G.O. No. 166-167

Dated 12-2-43

Survey - Frontier boundary - Bellary district and Mysore State - Boundary line between Ragi Masalvada and Singarahalli villages of Bellary district and Kondaji village of Mysore State - Discrepancies - Rectification - Ordered.

Joint Verification sketches
of
Bellary & Mysore state Boundary

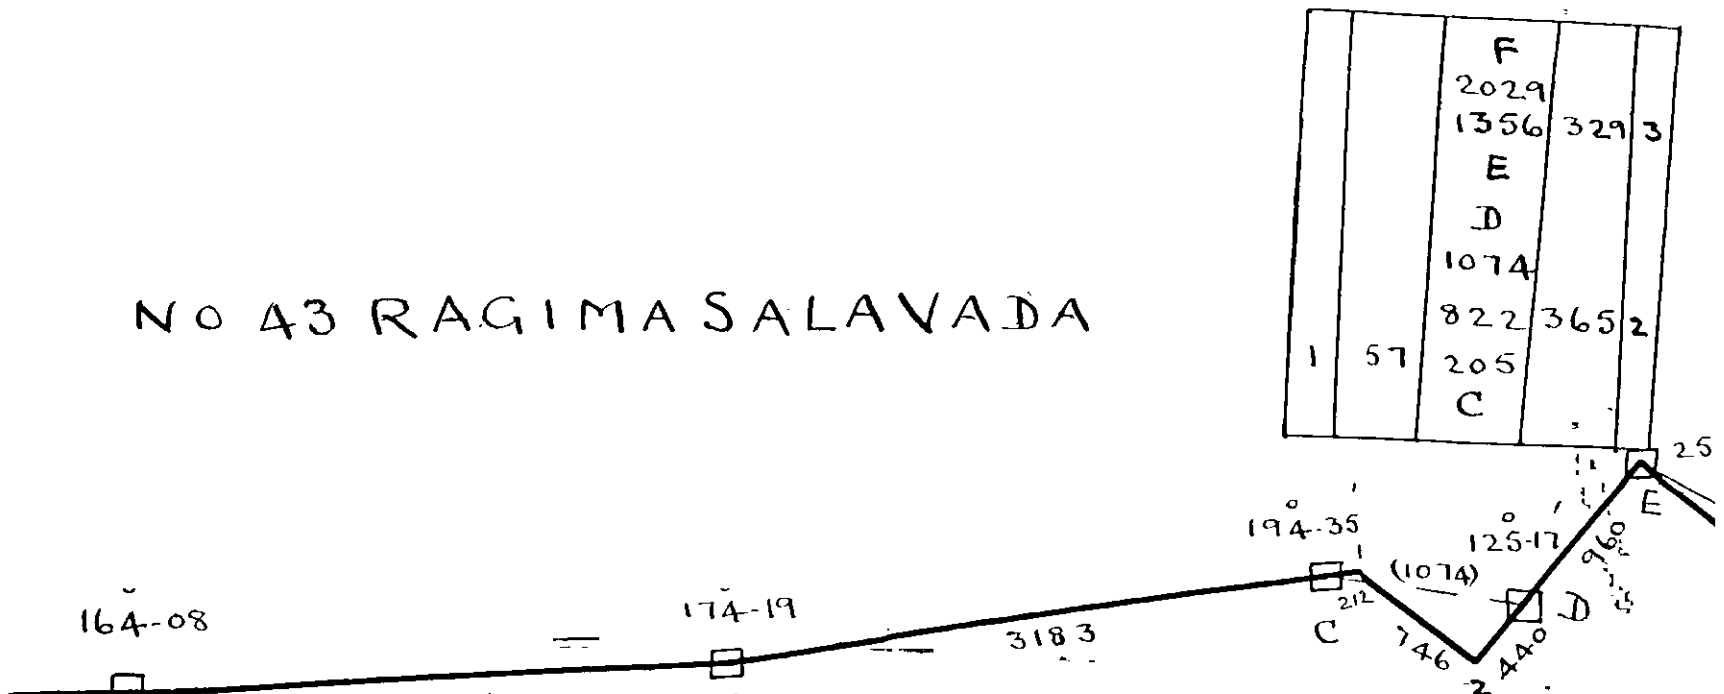
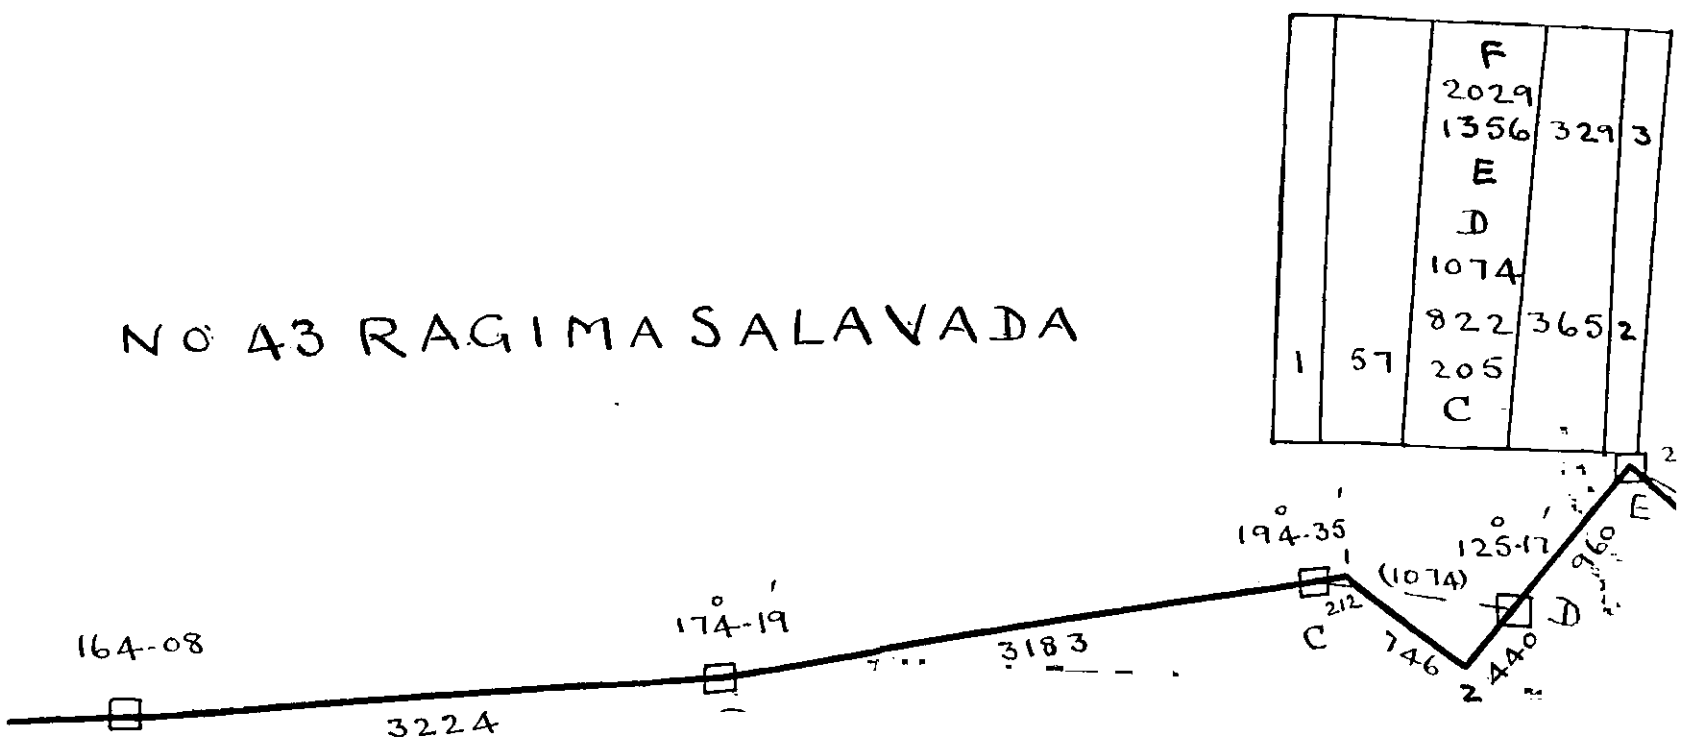
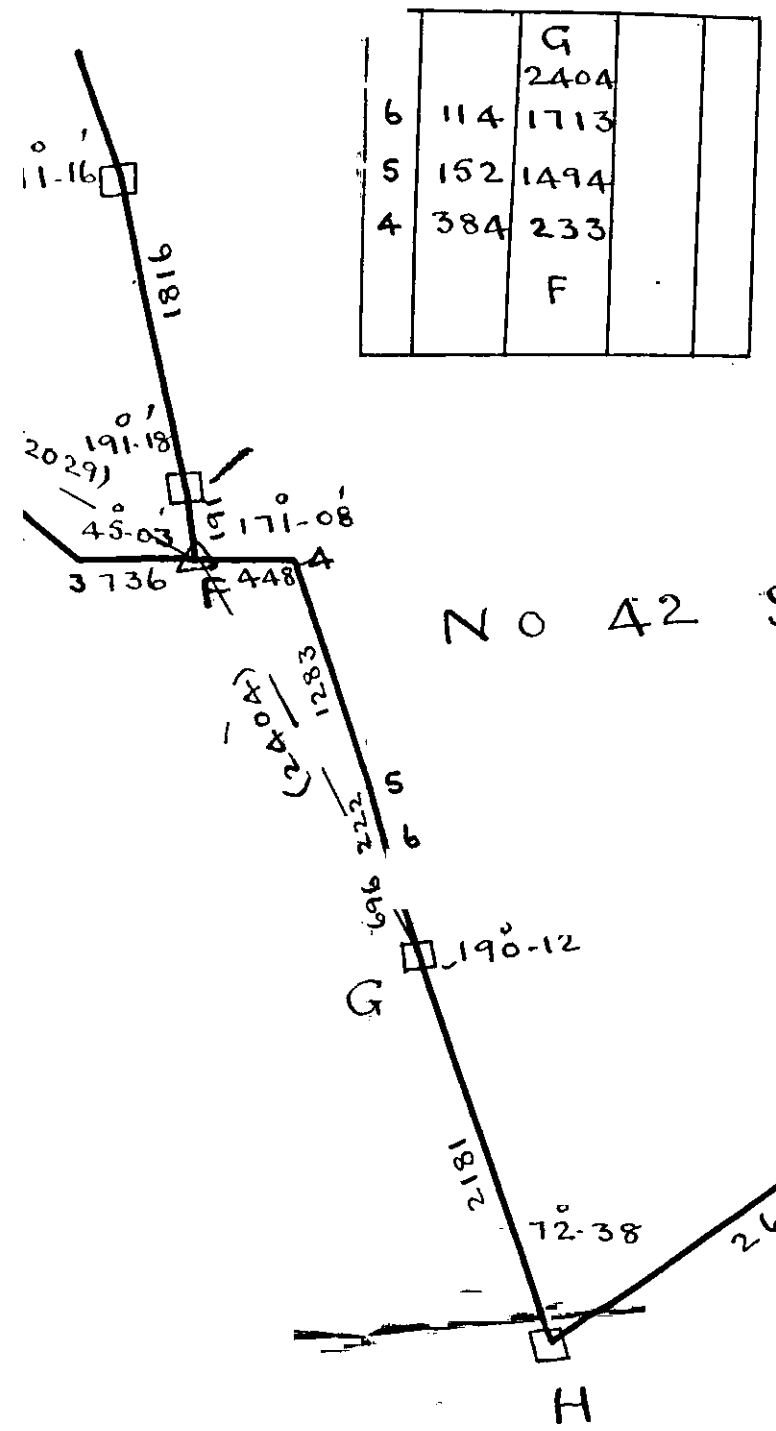
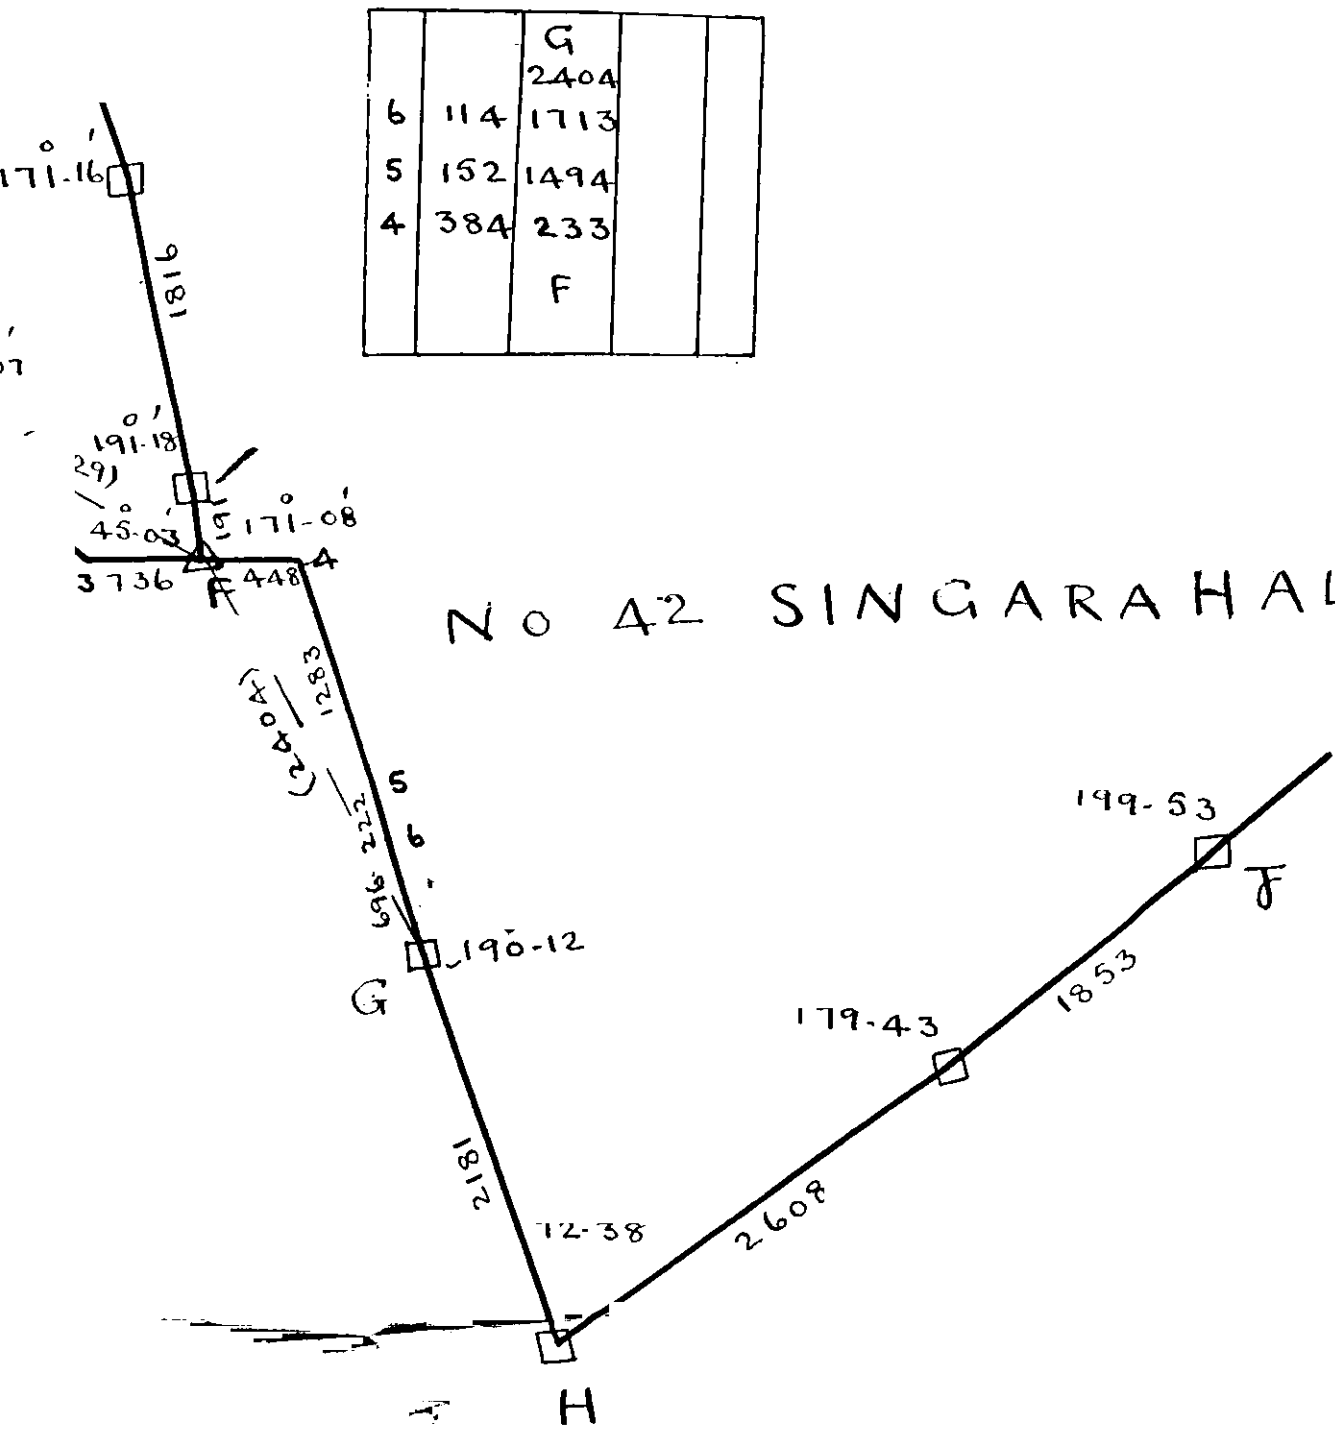
The Sub Collector Hospet who inspected the boundary in question jointly with the Officers of Mysore state, reports that the sketch received with the Board's Reference was of little or no use as it was not to scale. A revised sketch prepared, after consulting the Officers of the Mysore state., to agree with the actual state of things on ground is now enclosed. In this ~~actual-state-of-things-on-ground-is-now-enclosed.--In-this~~ revised sketch the portions which are claimed by the Mysore State and which have been included in the village maps on both sides are shown in blue and the portions which have been left out of Madras maps but actually belong to Madras are shown in Red. The Sub Collector Hospet after verifying the entire boundary line involved, reports that when the Madras boundary was surveyed, the Mysore boundary marks (Bands) which were in existence prior to the Madras Survey were over looked and the boundary lines taken from the easily identified boundary stones used by Madras Survey and that the boundary pointed out by the Mysore Officers' shown in red pencil line in the revised sketch is substantially accurate and recommends that it may be adopted The Mysore Survey being an earlier one it has to be accepted. The Frontier boundary between Ragi Masalvada and Singarahalli villages of Harapanahalli taluk, Bellary district and Kondaji village of Harihar taluk, Mysore state may be ordered to be revised in accordance with the Mysore Survey as shown in the revised sketch by the line drawn in red pencils.

6. I have satisfied myself that the statement as to the boundary made by the Mysore officers is substantially accurate and that the boundary may be laid as shown by me in the plan by a double line drawn in red-pencil.

of Bellary district and Kondaji village of Mysore state may be revised in accordance with the Mysore Survey as marked in red pencil in the revise sketch, submitted by the Collector.

In the circumstances ~~stated~~ reported, the governm
direct that the boundary line between
Ragi Masalvada and Singarahalli
villages in the Bellary Dt. and ~~Kondaji~~
Kondaji village in the Mysore State ~~should~~
be revised in accordance with the Mysore
Survey as marked in red pencil in the
revised Sketch submitted with the Board's
Ref.e read above. The Board is requested
to take action accordingly.

Ratified as per Government Endorsement No. 1780
D-G-47-5-Dated 9th January 1948.
